**ISSUE:** Permit to Demolish and Certificate of Appropriateness  
**APPLICANT:** Charles M. Sypula  
**LOCATION:** 733 South Fairfax Street  
**ZONE:** RM/ Residential Townhouse Zone

**STAFF RECOMMENDATION**

**BAR2015-00200 & BAR2015-00201**

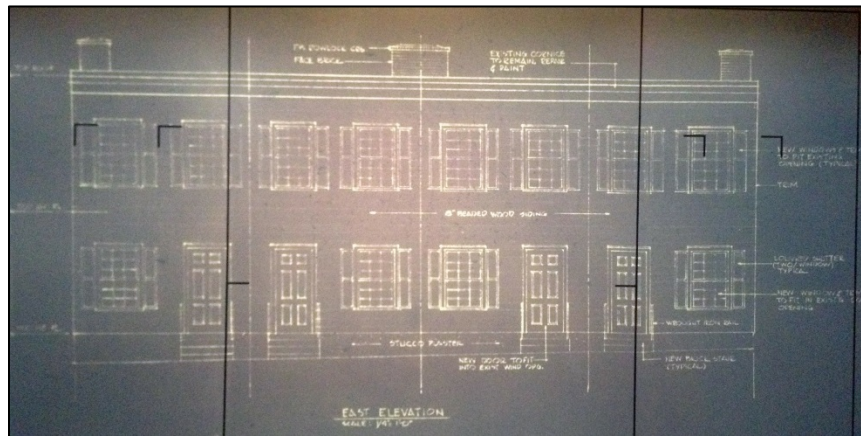
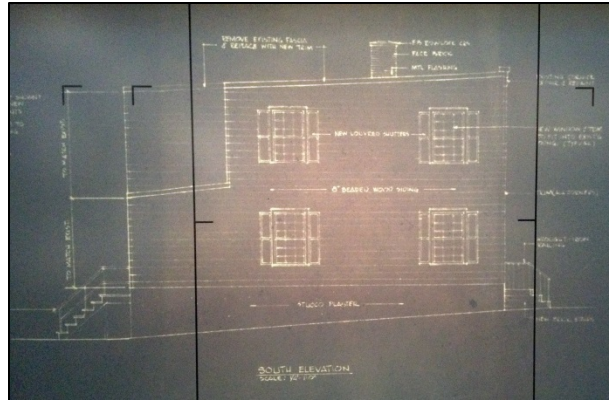
**Figure 2:** The sentiments of the developer are obvious in the description on this building permit #24296 from 1967 that reads: "I plan to take these old things and make beautiful townhomes". The permit regrettably lacks documentation of the houses prior to the renovation other than the photo shown in Figure 1. The elevations show a complete redesign of the exterior, including relocating several doors to former window openings. It is possible the chimney configuration was altered as well.

ELEVATIONS FOR PROPOSED  
 ADDITION  
 1/4" = 1 FOOT

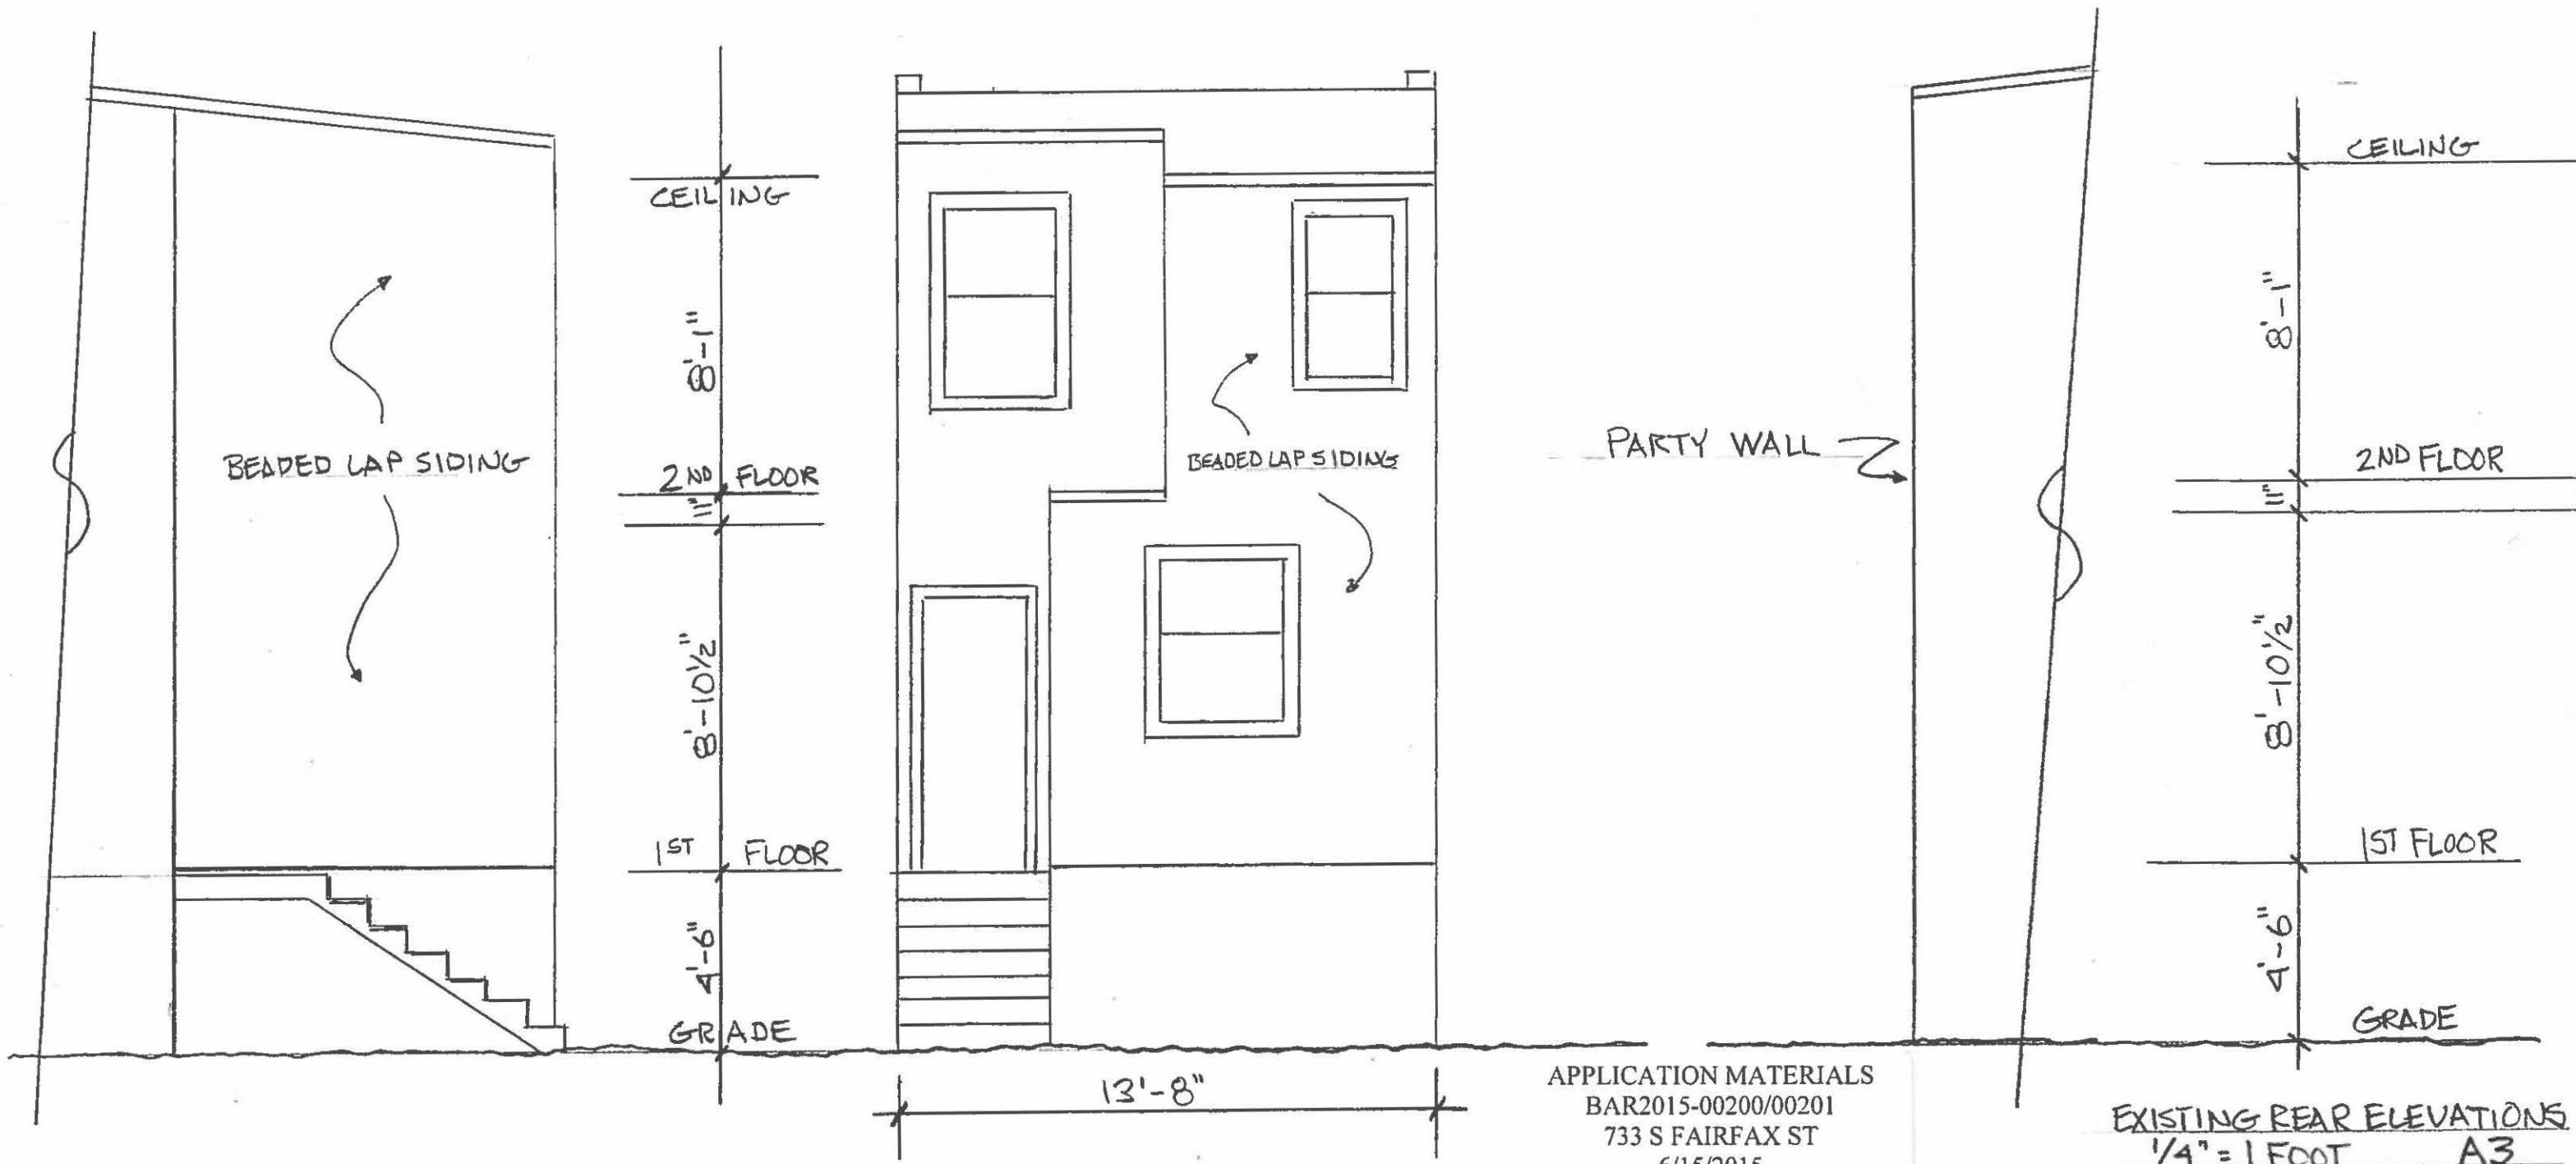
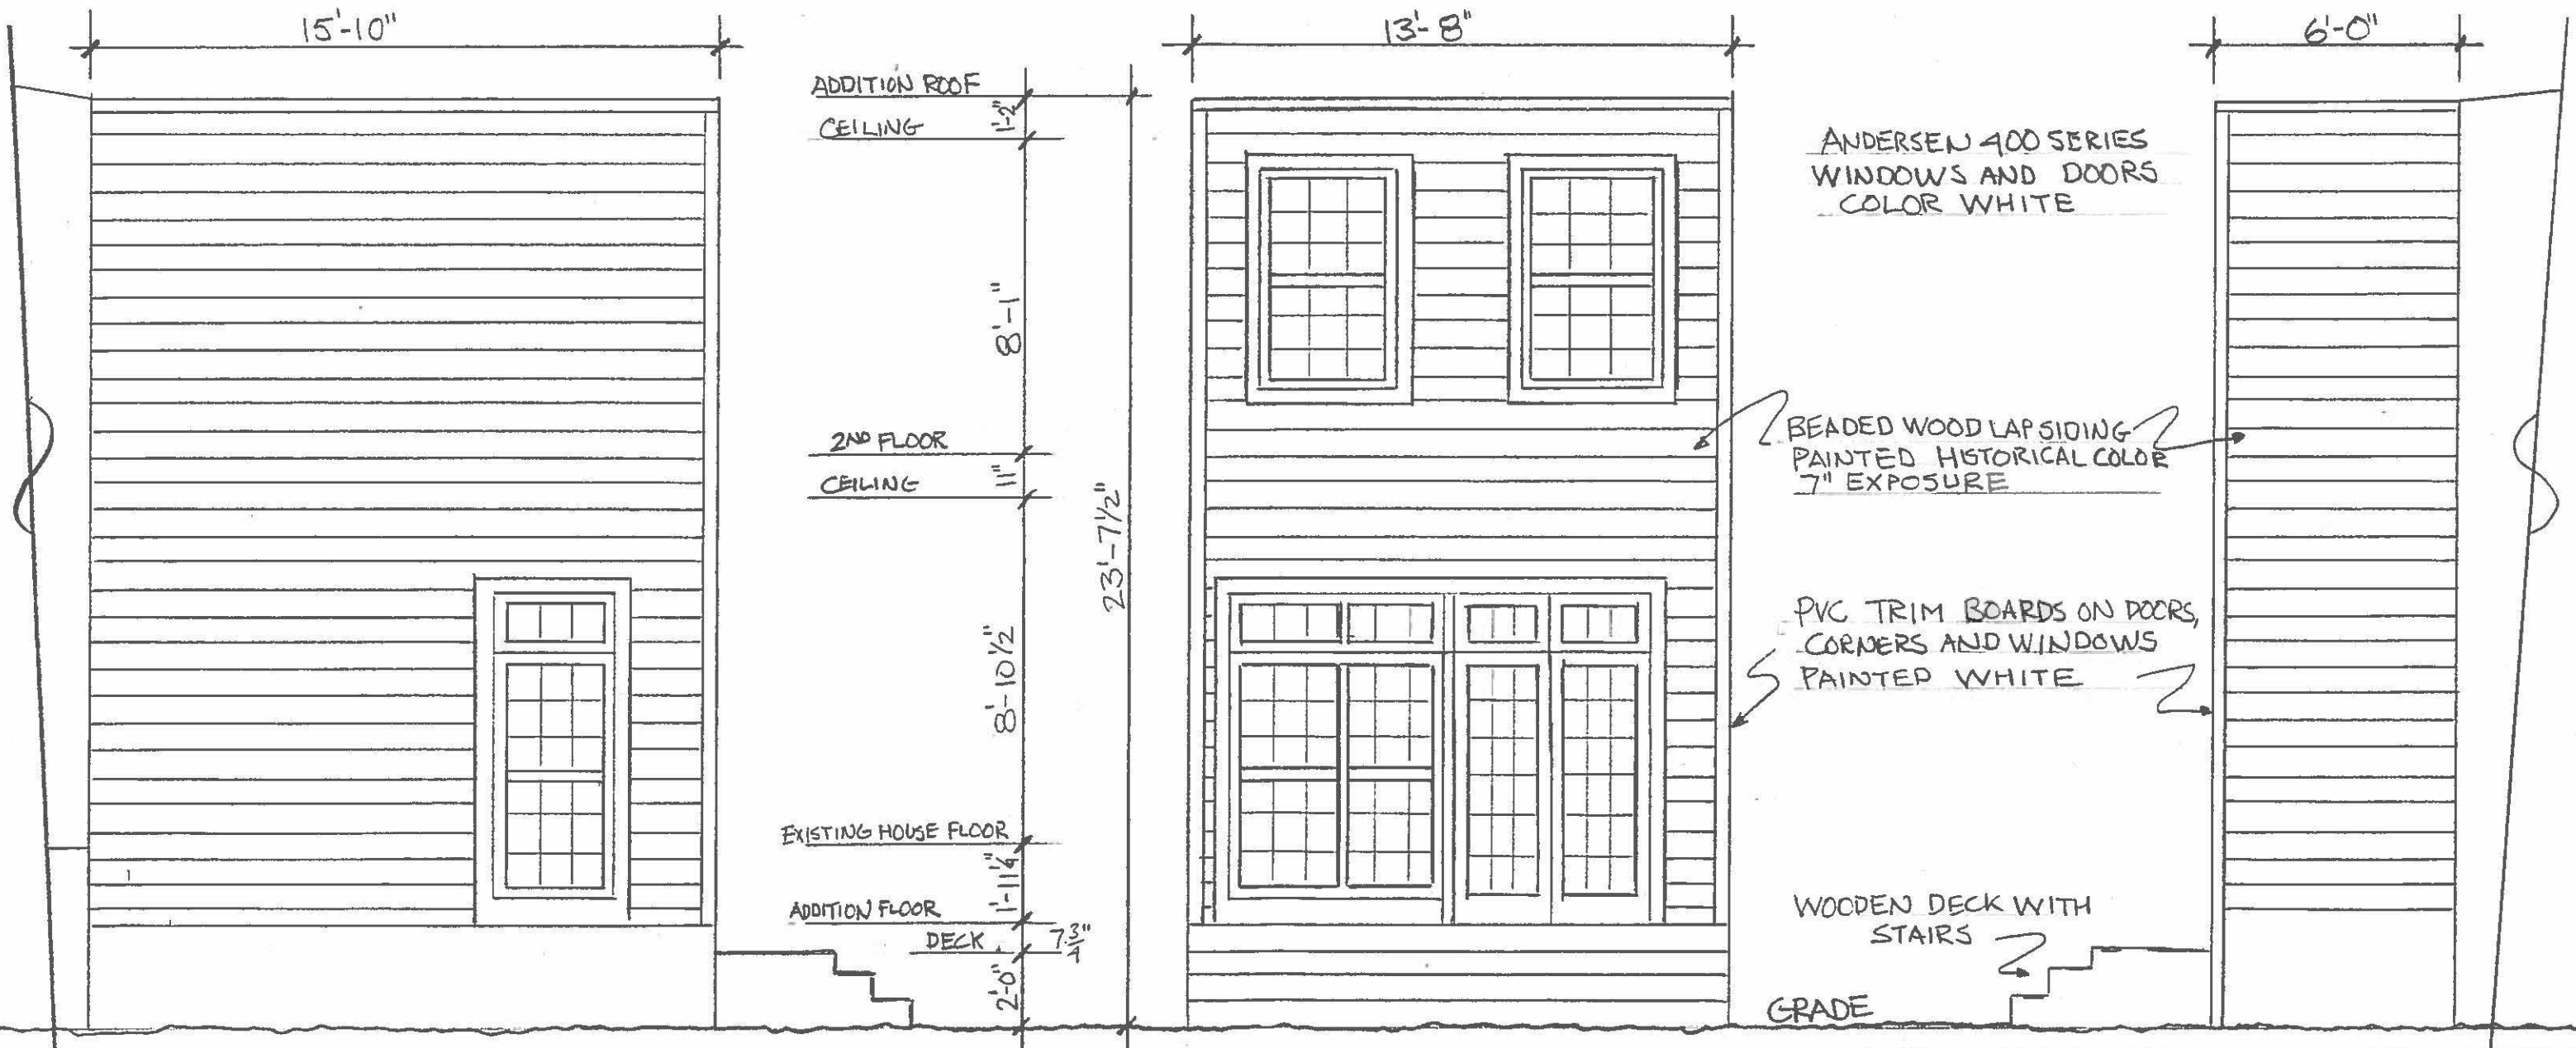
**Figure 3:** Once the shed is demolished, the rear elevation of the proposed addition will be clearly visible, until and unless a request for a 6 foot fence is made (left image). The proposed addition will extend an additional 6 feet, visible from Jefferson Street (right image).

Regarding the design of the proposed addition, the Board should consider whether an addition at this location should be sympathetic to the 1967 Marissa Smith Colonial Revival style renovation, reflect the Victorian-era construction date, or be decidedly different (ie: modern). Generally the Board has not dictated particular styles for new construction, but has weighed in on the scale, mass, materials, and general aesthetic of the chosen design. The applicant in this case has attempted to match the 1967 re-styling of the house.

Finally, staff notes that the application drawings are somewhat incomplete. Should the Board approve the addition, staff recommends that the Board require the applicant to work with staff to ensure the architectural detailing such as siding, cornices, trim, and windows are consistent with the design direction given by the Board at the hearing and consistent with all BAR policies.

Staff recommends approval of a Permit to Demolish the rear shed and approval of a Permit to Demolish and Certificate of Appropriateness for a rear addition that is *either* in keeping with the architectural style of the 1967 Colonial Revival renovation or with the late Victorian appearance. Staff recommends denial of a door hood and that any approval include the following conditions:

1. That the applicant work with staff during the building permit process to ensure the details, such as trim profiles are consistent with the Board's direction;
